FAO Anthony Devey,
East Riding or Yorkshire Council,
Planning & Development Control,
County Hall Cross Street,
Beverley
HU17 9BA

16th March 2015

Thank you for your correspondence dated 5th March 2015 regarding planning application 14/0288/STPLF.

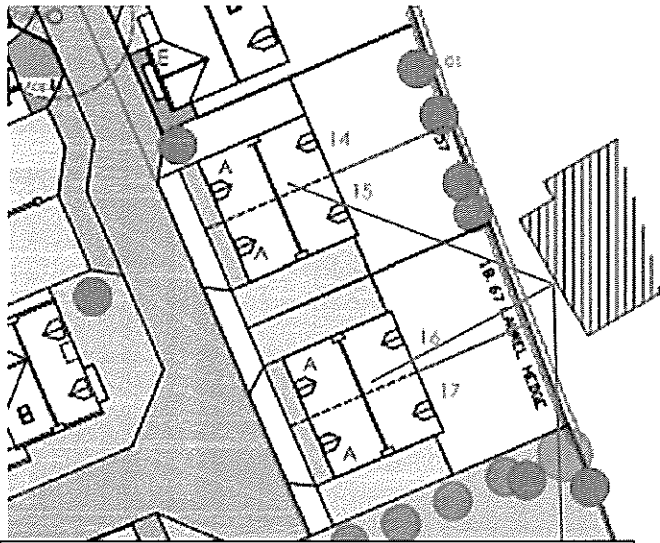
The picture below is the overlooking view from the bedroom in the west elevation of 14 Thornham Close. There would be no private space to the rear of the property for either plots 14-17 or 14 Thornham Close.

In relation to this the spacing (currently less than 10m) between the existing property and the proposed properties is not sufficient to minimise the impact of overlooking of plots 14-17 and loss of privacy for 14 Thornham Close.

Further to the above, there is insufficient spacing between the plots 14-17 and 14 Thornham Close meaning that the bedroom window of 14 Thornham Close directly overlooks the adjacent or opposite sitting areas, living rooms and bedrooms of plots 14-17. This is in direct conflict with the highlighted policies above and should be grounds for refusal.
